INFRASTRUCTURE PLANNING
THE INFRASTRUCTURE PLANNING (EXAMINATIONS PROCEDURE) RULES 2010
THE THANET EXTENSION OFFSHORE WIND FARM ORDER

Response to further information requested by the ExA (Responses to Action Points from ISH2) submitted on behalf of the Port of London Authority and Estuary Services Limited

Unique Reference Number	EN010084
Document Ref.	PLA7 / ESL7
Author	Winckworth Sherwood LLP
Date	15 January 2019

Sea Zones Plan – Reduction in red line boundary

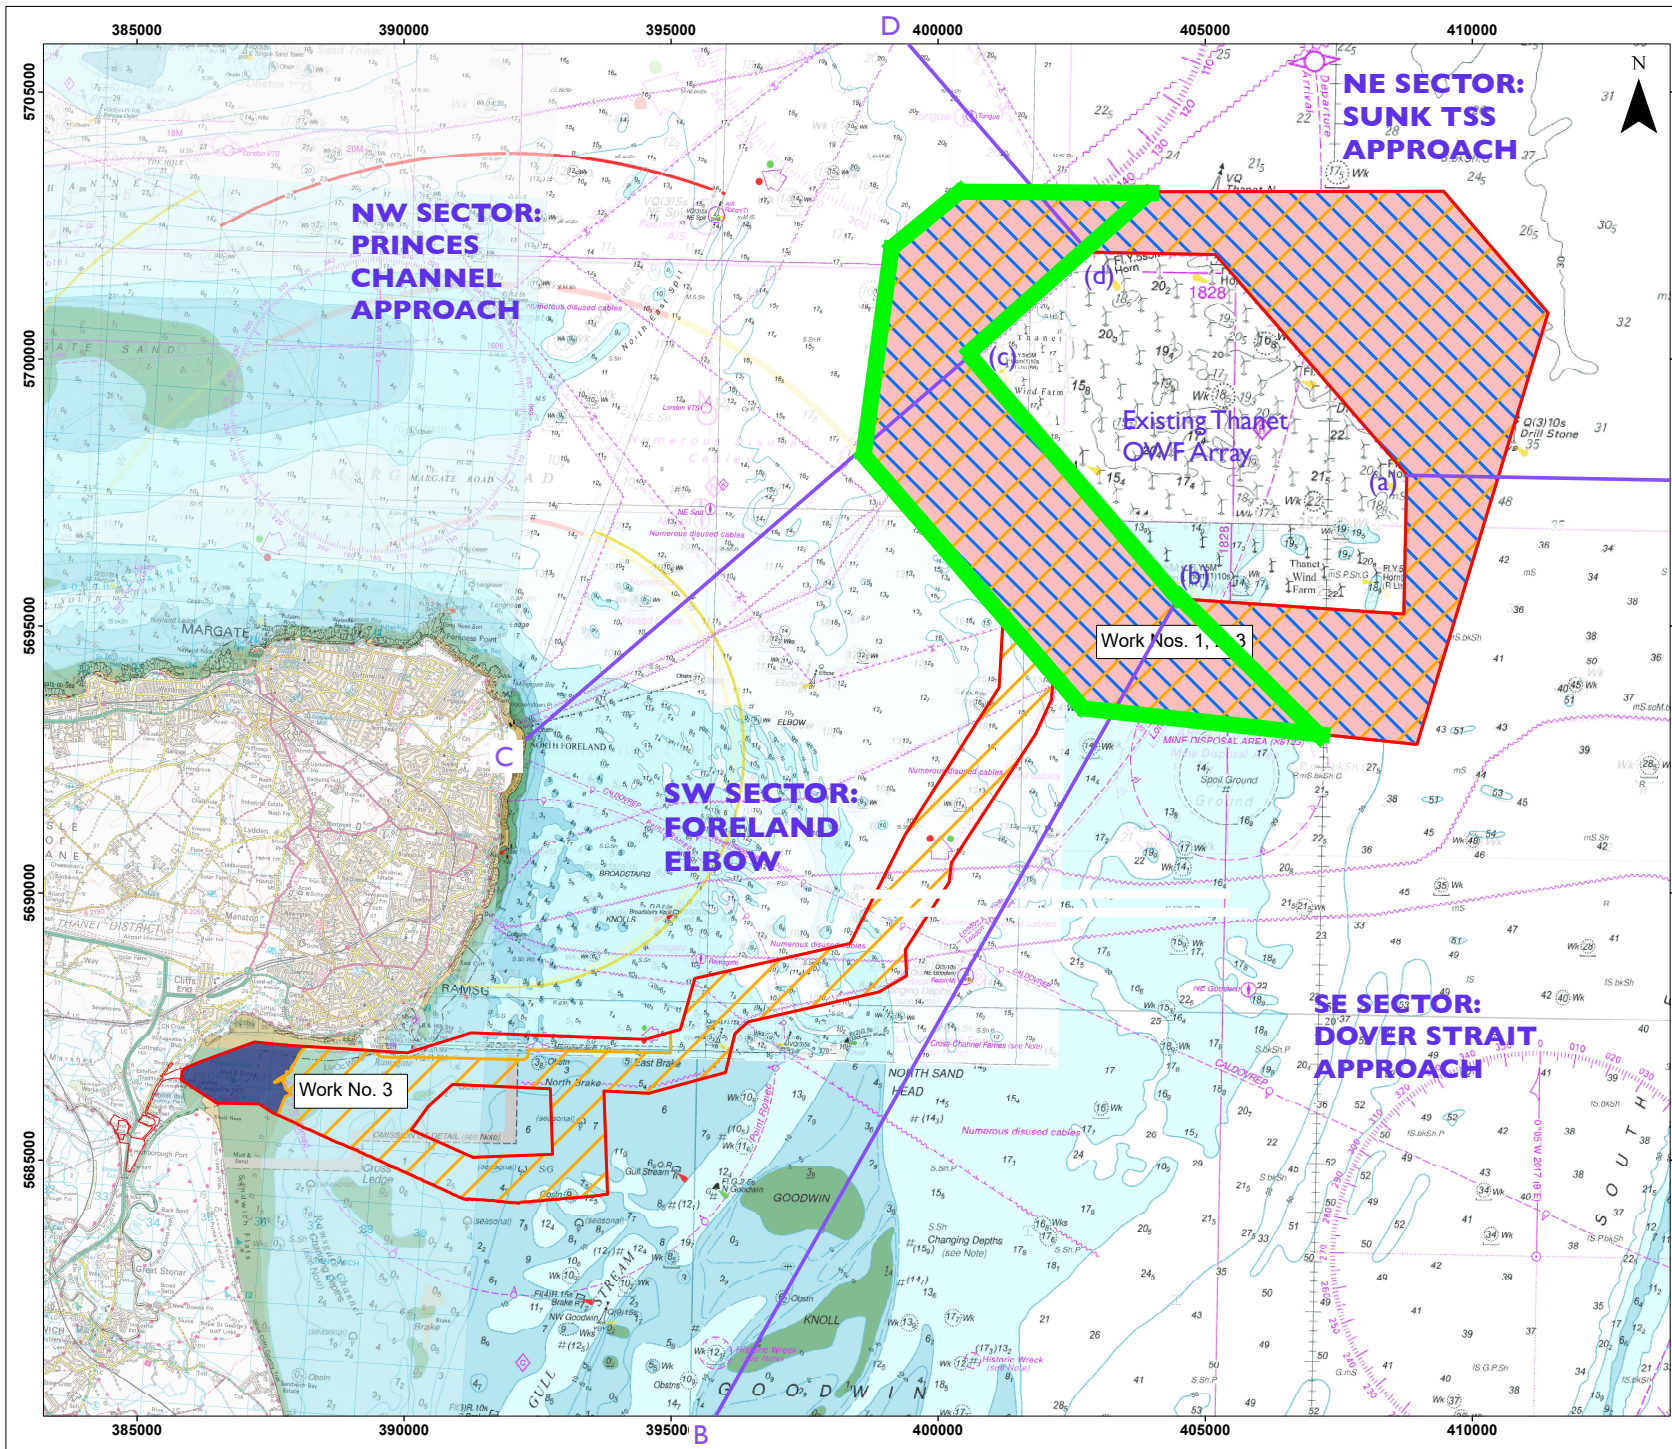
#	Action	Party	Response
	(d) If there is Fisherman's Gat capital dredge proposal, could it mitigate this diversion and if so, to what extent?	<i>PoTLL, LGPL</i> <i>[PLA and ESL also consider it appropriate to respond.]</i>	The use of Fisherman's Gat would reduce the voyage of a vessel coming up from the south compared to that vessel using the Sunk pilot station, but would not reduce the voyage for a vessel that would have used the inshore route.
7	<p>Red Line Boundary (RLB) Reduction Requests</p> <p>Where proposals to reduce the extent of proposed array area within the Thanet OWFE RLB were made at ISH2, parties making such requests are asked to provide:</p> <ul style="list-style-type: none"> • A plan based on the Sea Zones Plan [OD-008] identifying the extent of the proposed reduction; • A written justification, explaining and evidencing the need for the extent of the proposed reduction 	<i>All hearing participants requesting a reduction to the Red Line Boundary (RLB)</i>	<p>The copy of the Sea Zones Plan attached at Annex 1 shows edged in bright green the area of the proposed wind farm extension that the PLA and ESL propose should be removed from scope of the DCO application.</p> <p>North western area reduction:</p> <p>The Tongue deep water diamond (TDWD) is currently situated 1.7nm north west of the existing TOW boundary (line d). This area is typically used for handling larger vessels (over 200m loa and over 11m draft) but smaller vessels are served there as well. Whilst not used as frequently as the inner boarding position it has significant operational value to ESL and both of the ports (PLA and Medway). This area has been used 26 times in the last two months (01/11/2018 - 31/12/2018).</p> <p>The suggested extension north west will reduce the current 1.7nm to approximately 0.7nm which would be unacceptable. Therefore the current TDWD would have to be moved further to the NNE by at least 1.1nm (to maintain current distance) but possibly further if the full extension takes place and the boarding area to the south is relocated to allow for congestion.</p>

#	Action	Party	Response
			<p>force vessels to continue with an extended blue route.</p> <p>With the reduction to the south/south-west extension boundary the potentially diverted blue route traffic won't be faced with such a reduced passage and the deeper water along the western boundary of TOW remains available.</p>
10	<p>Marine Guidance Note (MGN) 543 Compliance</p> <p>Any allegations of MGN 543 non-compliance on the part of the consulting team for the Applicant in the preparation of the NRA [APP-089] in terms of guidance and methodology should be documented.</p>	<p><i>All hearing participants</i></p>	<p>The PLA and ESL do not agree with the Applicant that the NRA was undertaken fully in line with the requirements of MGN 543.</p> <p>MGN543 requires that the environmental impact assessment and resulting environmental statement (ES) (and therefore the NRA), "should evaluate all navigational possibilities, which could reasonably be foreseeable, by which the [...] extension [...] of an Offshore Renewable Energy Installation could cause or contribute to an obstruction of, or danger to navigation". Most of the data used for the NRA was from all or part of a three month period over the winter (see paragraph 5.1 of the NRA), which tends to be the quietest period of the year, for both shipping and recreational activity. Where there was seasonal variation it was still based on a month that was below the monthly average for vessels using the NE Spit pilot stations and outside of the busiest months for recreational activity.</p>

Proposed area for reduction shown edged green.
